Access Compliance Report Public Rights-of-Way (Curb Ramps)

Main Street: WOODGLEN_DR Cross Street: DODGE_AVE Location: SW

ADA ID: RPAT211018115922 Ramp Type: Type 3 - Combination 1 Initial Pass/Fail: Pass Overall Compliance: No Severity Score: 6

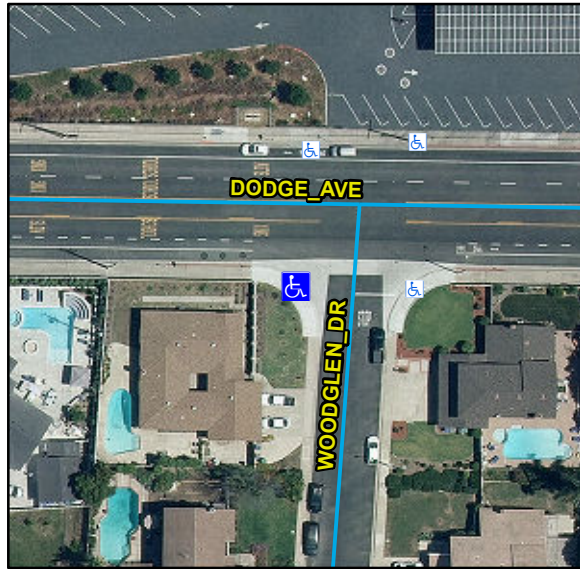
Remove & Replace Landing. Remove & Replace Gutter.
